PLANNING COMMISSION VOTE REPORT

Subject: Change of Zoning Issues Report

Meeting Date: July 9, 2012

Petition: P.Z. 02-2012 Mercy Health Systems (Chesterfield Village, SE Quadrant)

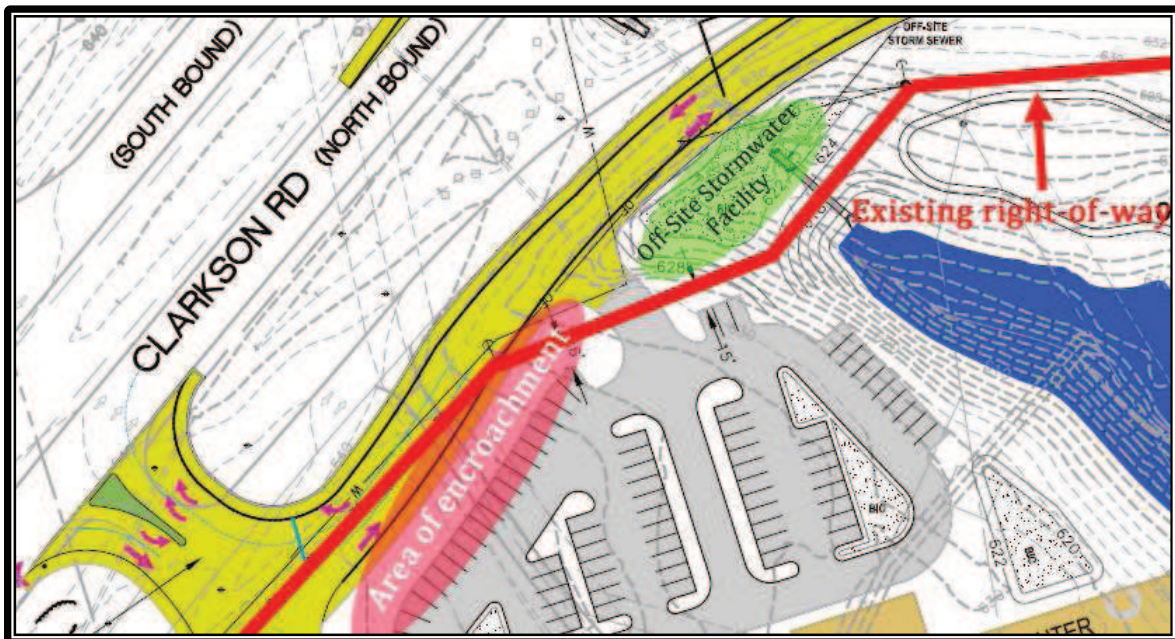
Prior to the Issues Meeting, the Petitioner advised Staff of their concern with the building height presented in the draft planned district ordinance for the 'S. Outer 40 Area.' The height requirement included that no buildings would be permitted to exceed 715 feet above mean sea level. The Petitioner indicated they would like this restriction to be 725 feet above mean sea level. No issues were raised with this change at the Issues Meeting and the attached planned district ordinance includes this change.

There was also discussion regarding building height restrictions and the exclusion to permit rooftop mechanical equipment above the height requirement. Staff has researched previous projects, focusing on office buildings adjacent to residential properties, to clarify how the City has interpreted this requirement in the past. Staff found: (1) All development researched permitted rooftop mechanical equipment to exceed the height limitation; and (2) Penthouses have, in every example reviewed by Staff, been classified as rooftop mechanical equipment.

While a potential penthouse may exceed the maximum height, no useable floor area would be permitted. **Any proposed useable floor area in the penthouse would require the penthouse to meet height requirements.**

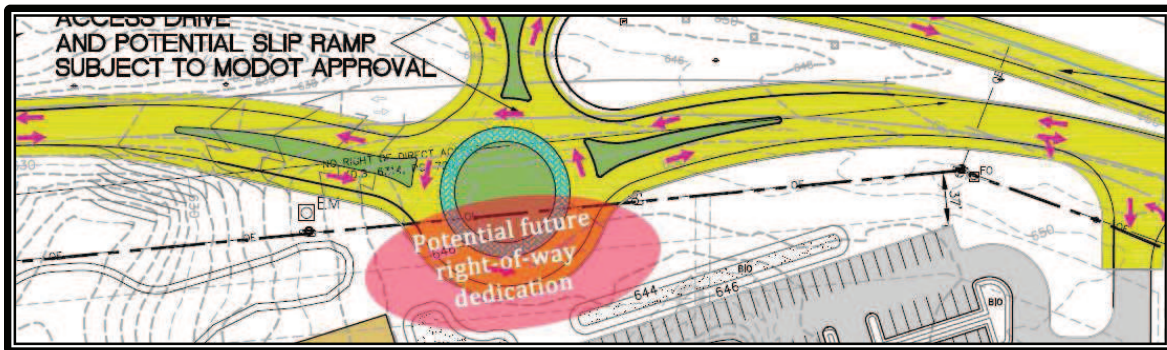
The Preliminary Plan shows an internal drive along the western side of the property that encroaches into the required 30 foot setback for internal drives. The Petitioner is requesting the setback along the western district boundary be modified to 10 feet. No issues were raised with this request at the Issues Meeting.

In addition to the request to modify the requirement to permit an internal drive within 10 feet of the western property line, the Petitioner is also now requesting a modification to the parking setback on the northern district boundary to permit a surface parking area within 15 feet of the northern district boundary. This request is primarily being made due to the irregular shape of the right-of-way along the northern frontage. As can be seen below, there is also additional right-of-way to facilitate stormwater management on the western end of the frontage. Further, a modification to allow parking within 15 feet of the northern district boundary facilitates the plan to preserve a maximum amount of open space along the southern district boundary.

Two separate votes by the Commission are required to (1) reduce the western setback from 30 feet to 10 feet for the drive isle; and (2) to modify the northern parking setback from 30 feet to 15 feet.

Since the previous meeting, Staff has also identified the potential requirement for right-of-way dedication. This complicates the Petitioner's process as the exact location and requirements of public agencies (City, County, and State) will vary and the future needs are not known at this time. Additionally, Staff has identified a potential public benefit if the east and / or western drives were public roads. Future analysis of these areas will be done during the site plan review process. It is important to note that the planned district ordinance defines setbacks from the boundaries of the 'UC' District. The district boundaries, whether right-of-way is dedicated or not, will remain as shown on the Preliminary Plan and site development plans will include setbacks from the district boundaries.

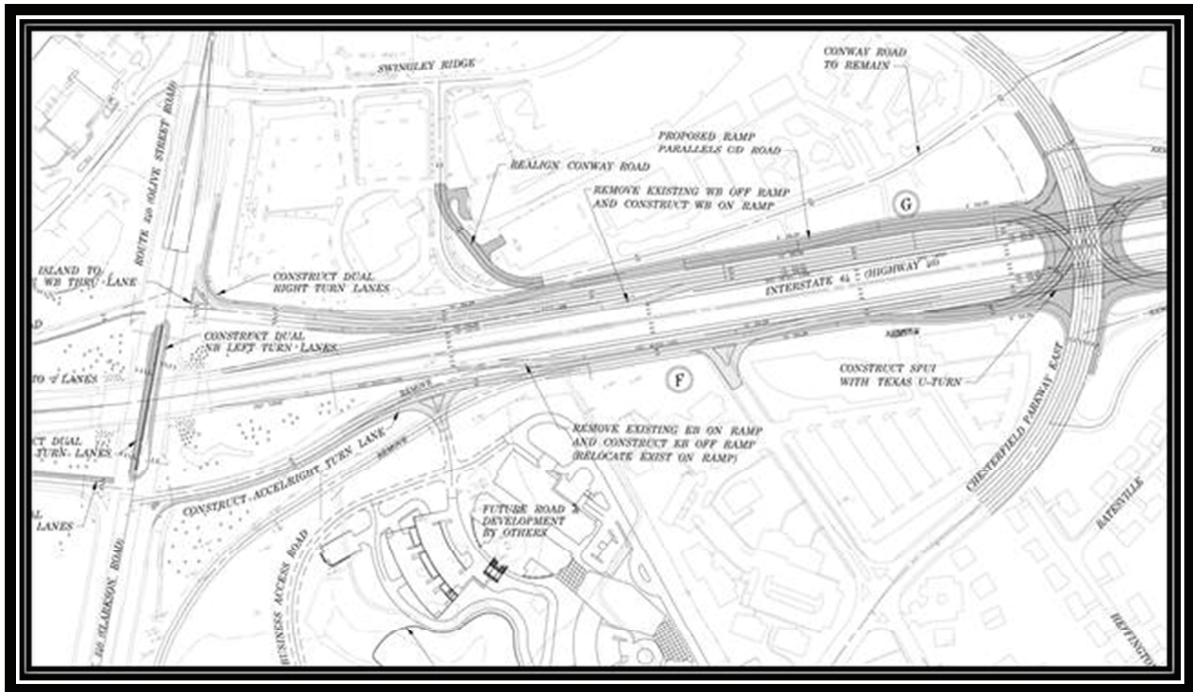
In 2002 the City of Chesterfield hired a traffic consultant to complete a Travel Demand Model and City Wide Transportation Study. This effort identified future areas where deficiencies in the network can be anticipated based on different land use scenarios. This effort was updated in 2008 when the City again hired a traffic consultant to convert the model utilizing new software and update potential development scenarios. Following the conversion, input update, and recalibration effort, several new roadway improvements were analyzed and additional improvements were identified in the study titled *Traffic Demand Model Review of Conceptual Major Roadway and Highway Improvements*. These new improvements generally were focused on providing additional access and mobility to areas along I-64 in the area of the Urban Core.

The image on the next page shows a portion of the approved plan for this petition. It is important to note that this plan includes specific design features (e.g. a Single Point Urban Interchange at Chesterfield Parkway E). However, it should be acknowledged that this configuration is based on preliminary planning level analysis and a more detailed, cost constrained analysis will be performed prior to each improvement. While future, detailed studies will finalize the recommendation for improvements in these areas, the planning process is still highly valuable as this process is utilized to identify the key concepts and result in a well-defined and comprehensive system, as well as to identify areas where future improvements will be needed. Of importance in reviewing the request in P.Z. 02-2012 in relation to the image on the next page is the extension of the outer road system to provide consistency in the network. Additionally, capacity improvements will likely be necessary at the Chesterfield Parkway E interchange with I-64 / Outer Road system in the future.
